PROPOSED COMMERCIAL DEVELOPMENT, CLIFTON STREET, MANCHESTER
APPLICATION REFERENCE: 139600/FO/2024
RESPONSE TO MCC COMMENTS – NOVEMBER 2024

This particular note will response to comments made by Manchester City Council (MCC) which were relayed by the planning officer by e-mail to the applicant dated 16th October 2024. Each MCC comment will be listed below in italics with Eddisons response next to each one in normal text.

CrashMap Image

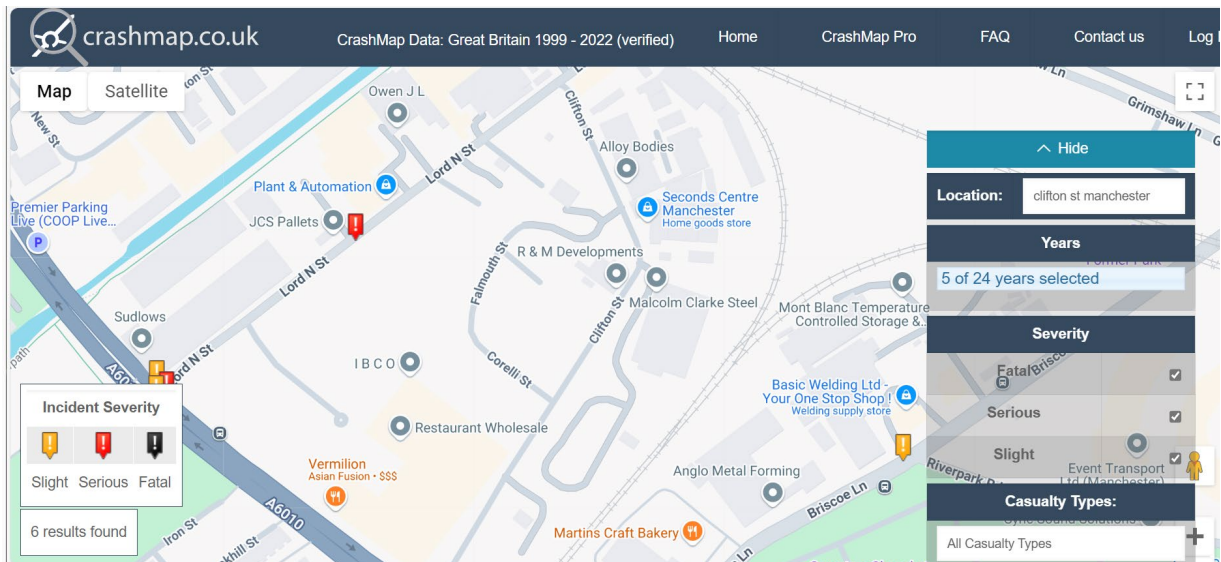
MCC Comment – ‘Highways would expect that the TS includes an assessment of local collision data, although this has not been provided. This should be submitted as part of a TS Addendum, along with the additional requests as identified herein.’

Eddisons Response – given the very limited traffic impact of the proposals we are of the view that a collision analysis would not typically be required. However, the CrashMap website has been reviewed and there have been no personal injury accidents on Clifton Street in the past 5 years. An image of the CrashMap website is shown below.

DRAWING NUMBER:	4325-F01	REVISION:	-
-----------------	----------	-----------	---

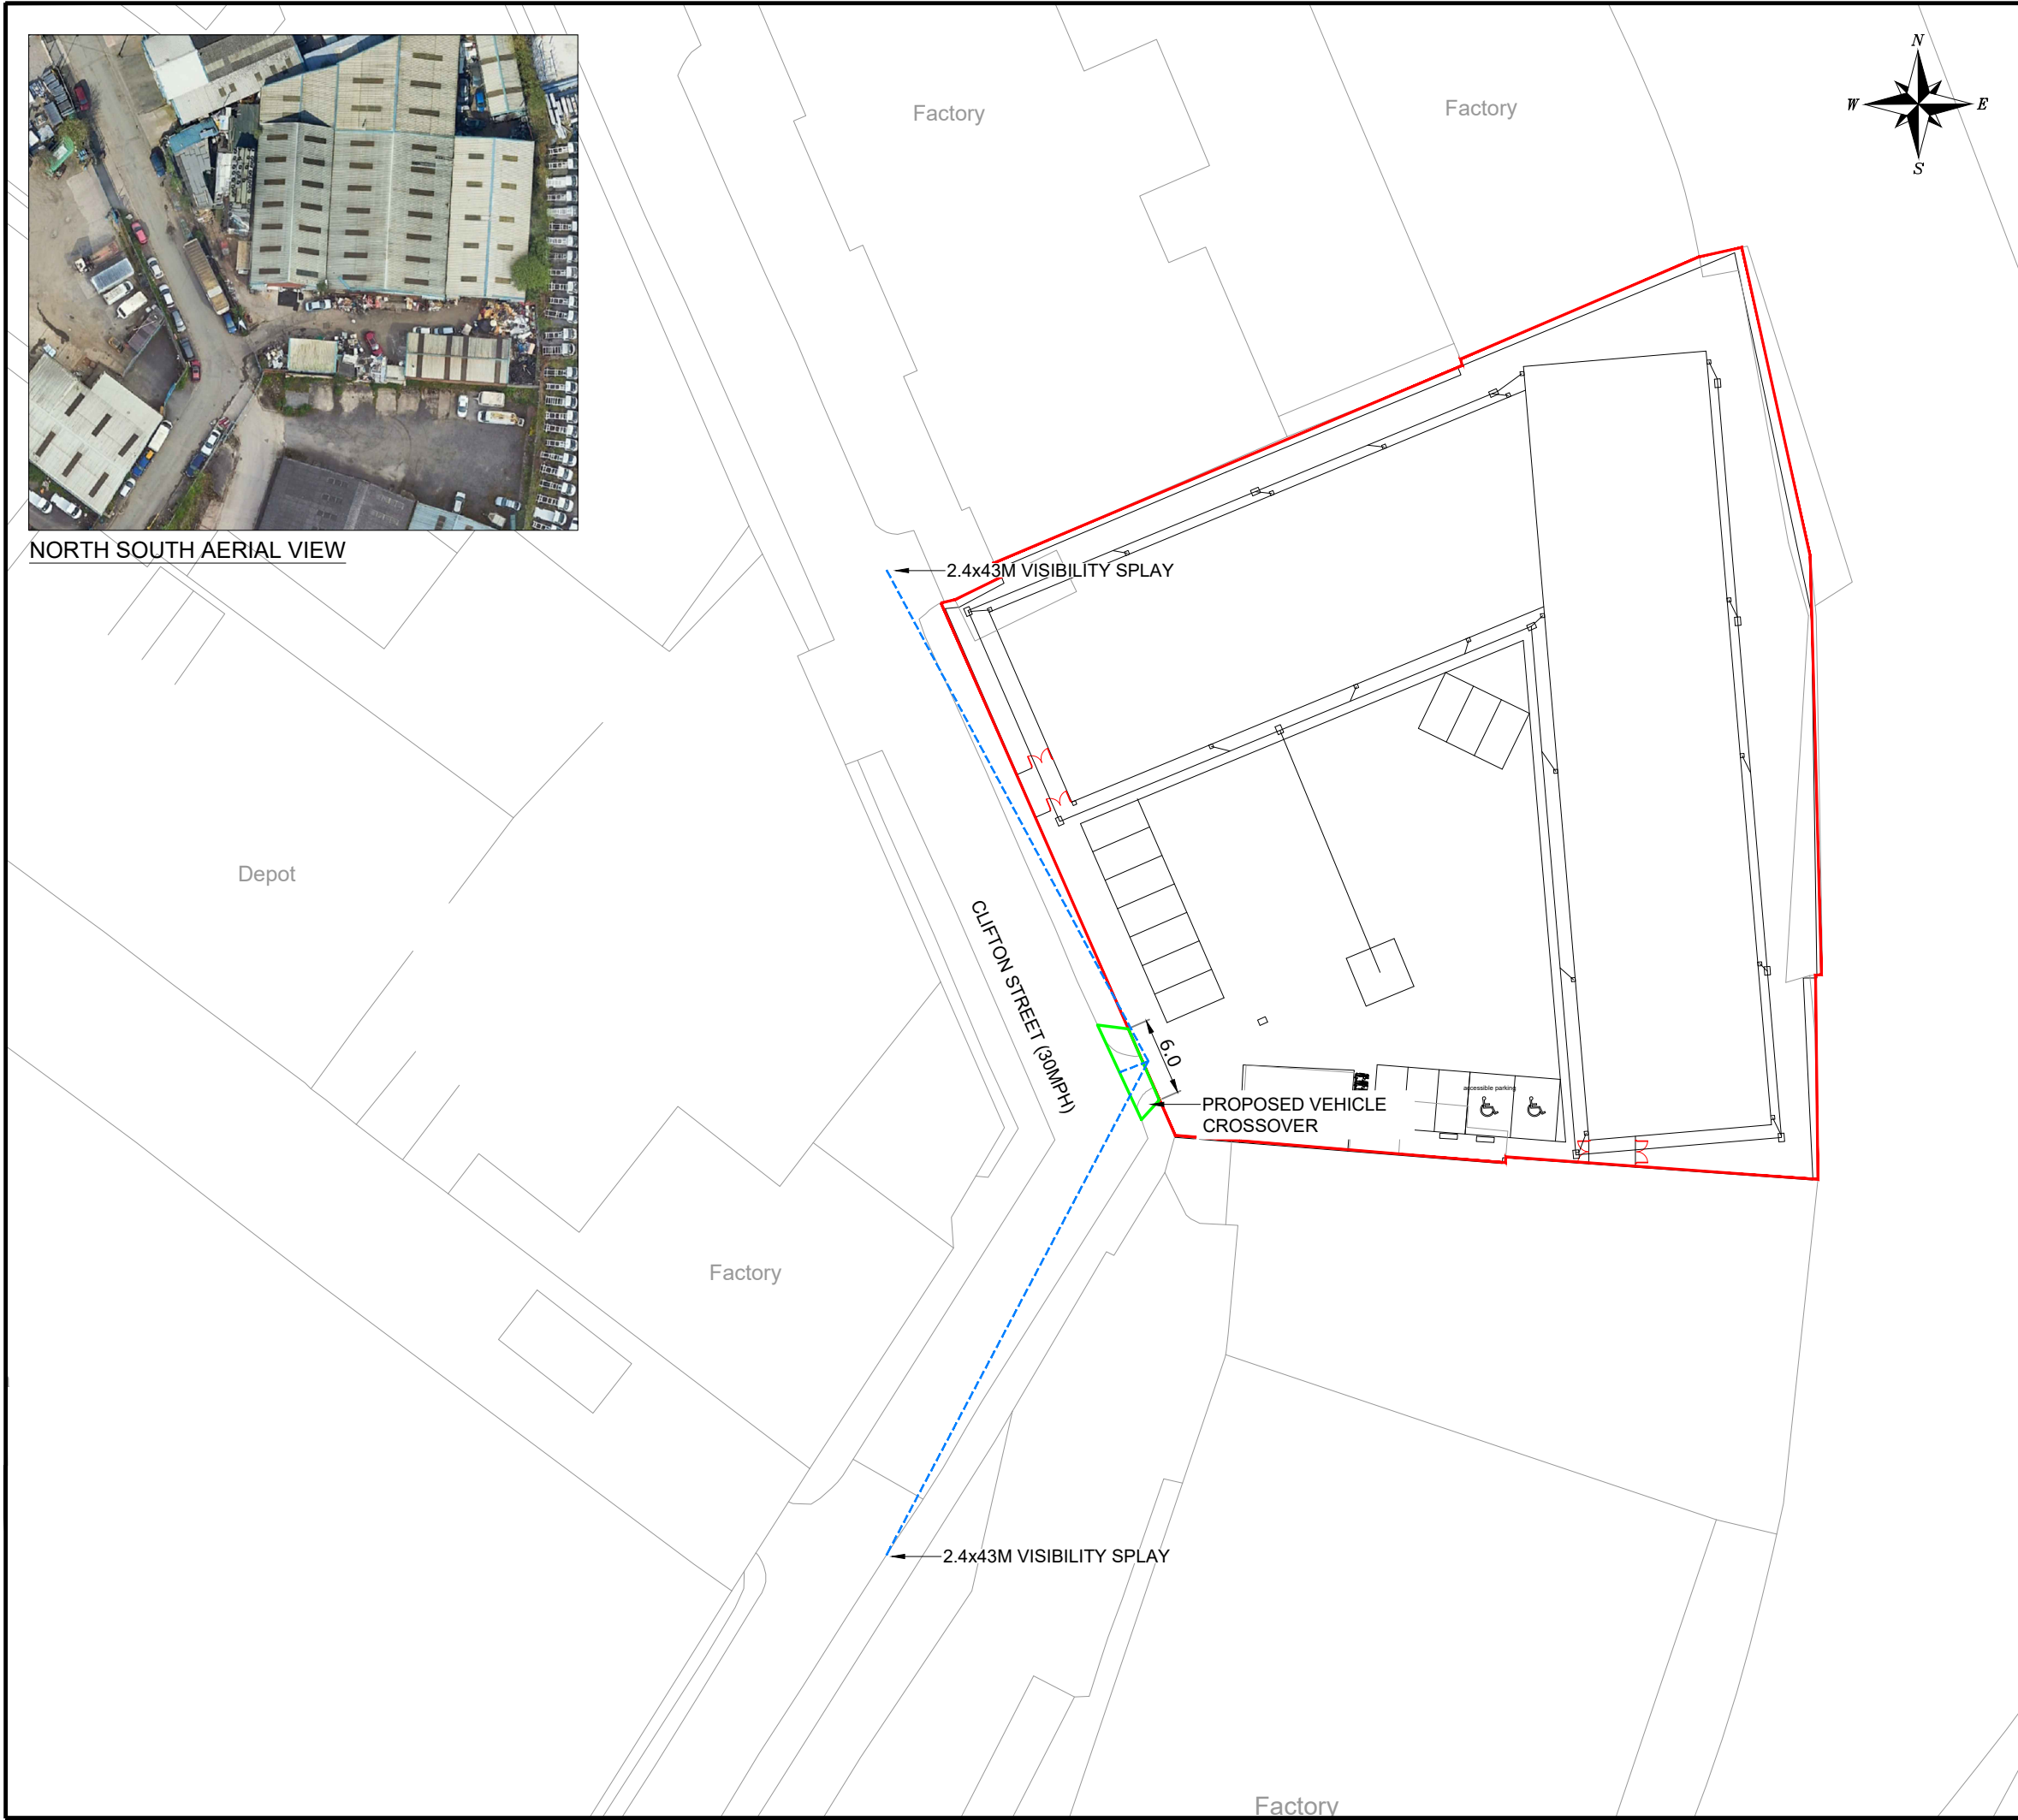
MCC Comment – ‘The site will be accessed via the existing access junction off Clifton Street. A dimensioned plan should be provided with supporting swept-path assessment which demonstrates that the existing junction geometry can safely accommodate two-way movement. Acceptable levels of vehicular visibility should also be confirmed by a visibility splay assessment. Site boundary features should also be of permeable construction above 600mm in height in the vicinity of the site access to ensure safe levels of pedestrian visibility.’

Eddisons Response – a Site Access plan has been prepared and has been shown on Drawing Number 4325-F01 and has an access width of 6 metres and can accommodate visibility splays of 2.4 metres by 43 metres in both directions and each splay can be accommodated on currently adopted highway. A revised swept path analysis using a standard MCC refuse vehicle has been shown on the revised site layout and is shown on Drawing Number 4325-SP01. This demonstrates that both the access and swept path analysis works safely and efficiently.

DRAWING NUMBER:	4325-SP01	REVISION:	A
-----------------	-----------	-----------	---

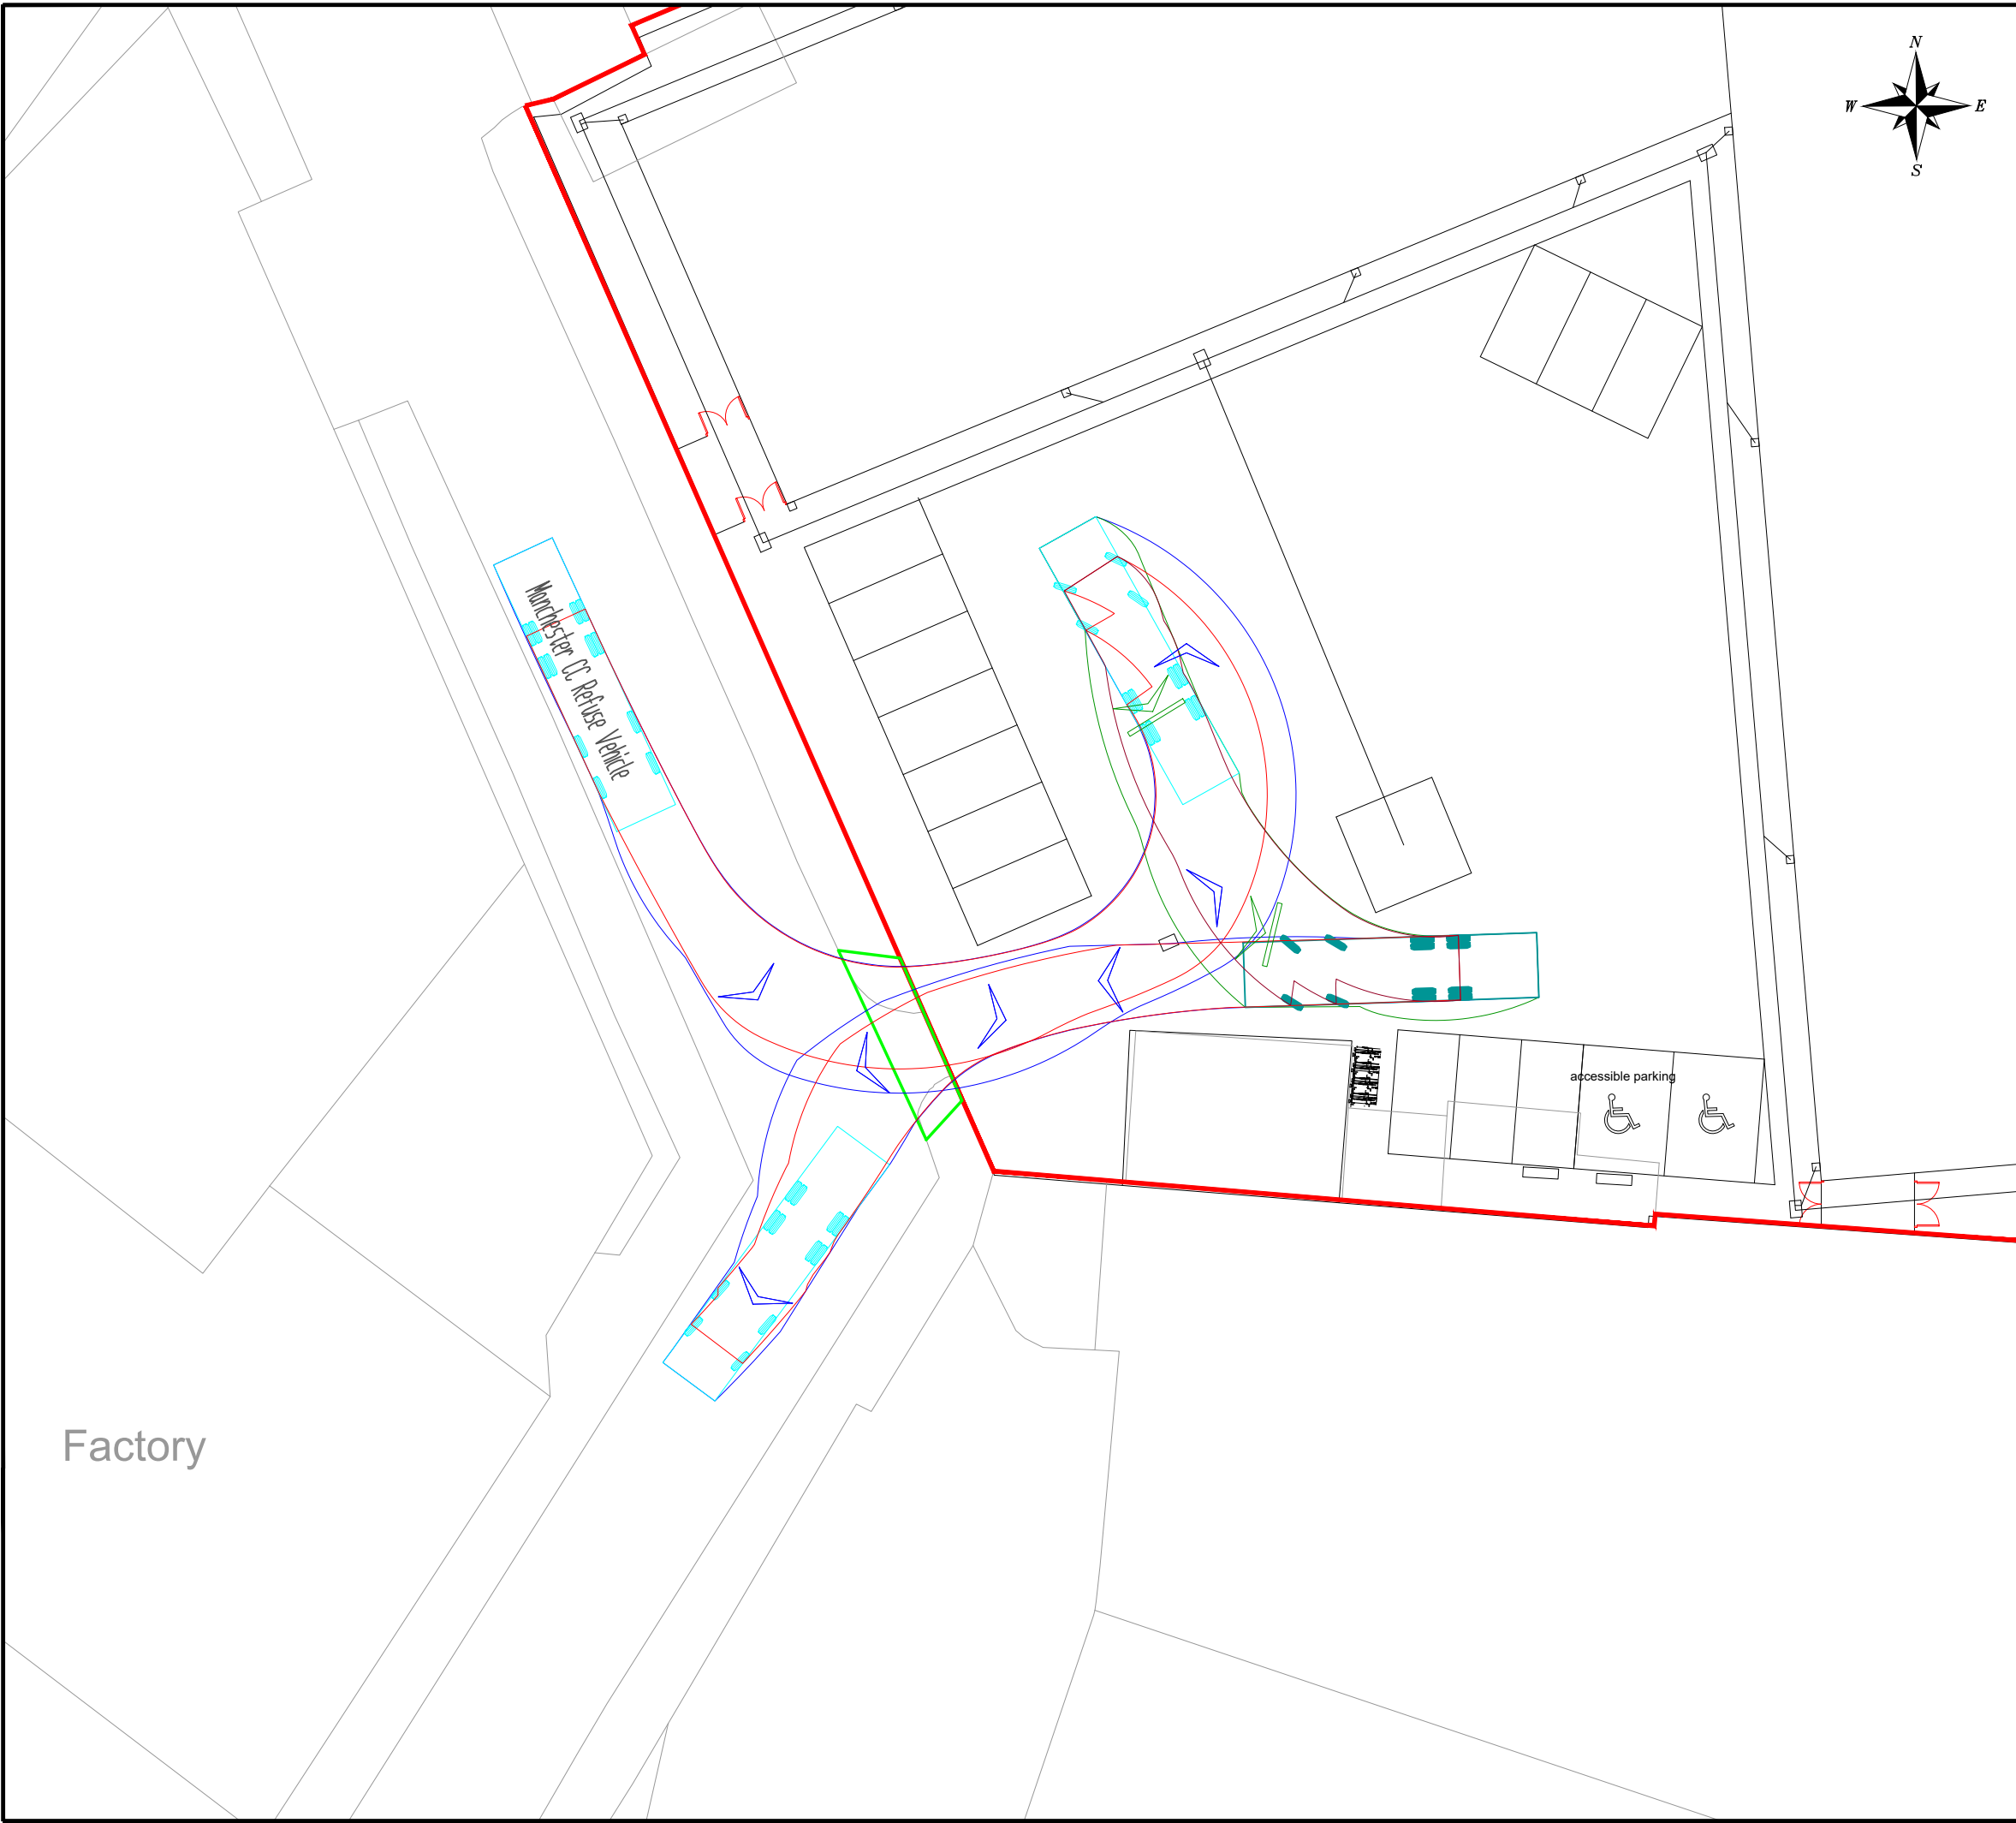
MCC Comment – *‘Two bin stores are proposed, with one located adjacent to each building. The TS makes reference to refuse vehicle access although no swept-path assessment is provided. Furthermore, no details regarding other delivery/servicing vehicles (including HGVs) have been provided. Given the proposed land-use, and proposed 6no. loading areas associated with the building, Highways would expect further details of such vehicle movements along with associated swept-path assessment.’*

Eddisons Response – as detailed above Drawing Number 4325-SP01 provides a swept path analysis of standard refuse vehicle accessing the site safely and efficiently and also ensuring that it enters and leaves the site in forward gear. This will be the largest vehicle that is likely to visit the site and this can be conditioned if required.
